CITY OF CROSSLAKE

PLANNING COMMISSION/BOARD OF ADJUSTMENT

PUBLIC HEARING NOTICE

STAFF REPORT

EXHIBIT A

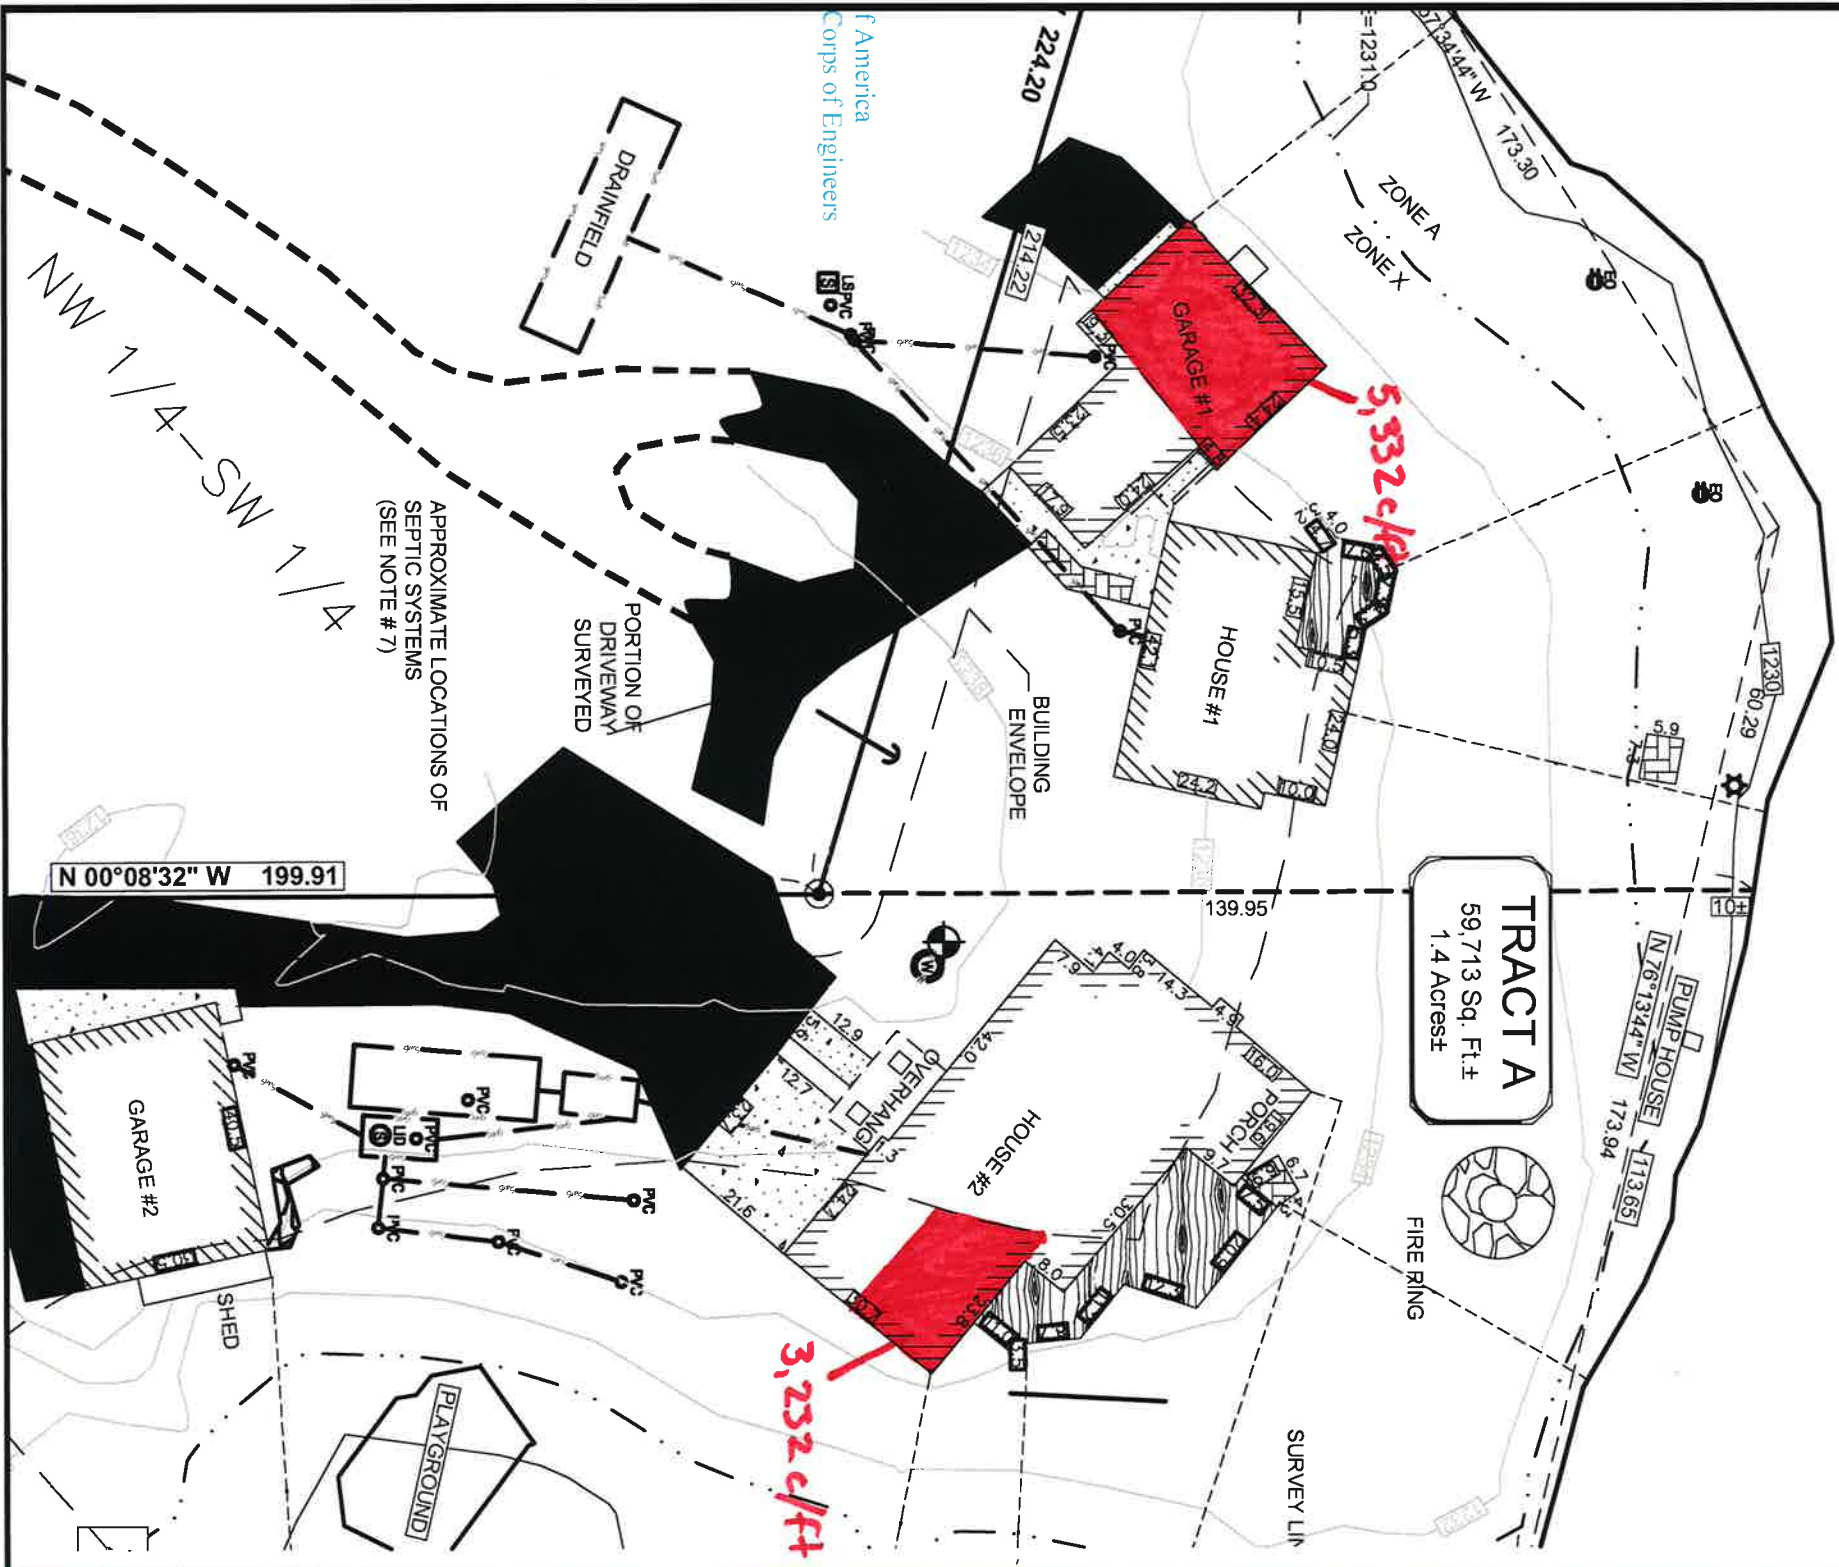
- Exhibit labeled "Proposed Final Project" and dated; to show only what will be remaining if the variance is approved with all of the setbacks and dimensions; anything that is not on the exhibit will be considered to be removed; paperwork in three phases - cert of survey, existing and final

- Survey and exhibit to show the dimensions and setback of the pickle ball court and fire pit along with the total square foot that will be in the SIZ1 and/or SIZ2

- Location of proposed well relocation on survey
- Removal buildings are listed in square footage per zone and height; discussion on the variance request as far as structure height and wording such as lake setback for 6250 sq structure where 1284 sq is needing a variance

- Water oriented accessory structure (WOAS) is either the brick patio or fire pit area; possible condition to remove one of them

- Label the 75' setback from OHW on each side of the parcel on the survey, as well as showing and labeling the SIZ1 on the exhibit
- Bench mark installed by surveyor and supplemental data form maybe required to verify elevation is being met of 1232.5

- Proof of US Army Corps of Engineers authorization to have the septic located on their property or labeled on the survey to be removed and abandonment papers filed at the city

The Corps has reviewed your submitted plans to use the existing septic drain field located on government property as part of the stormwater management system for the subject property and we have no objections. Once construction of the new home is completed we will issue an updated easement with an accurate description of drain field purpose.
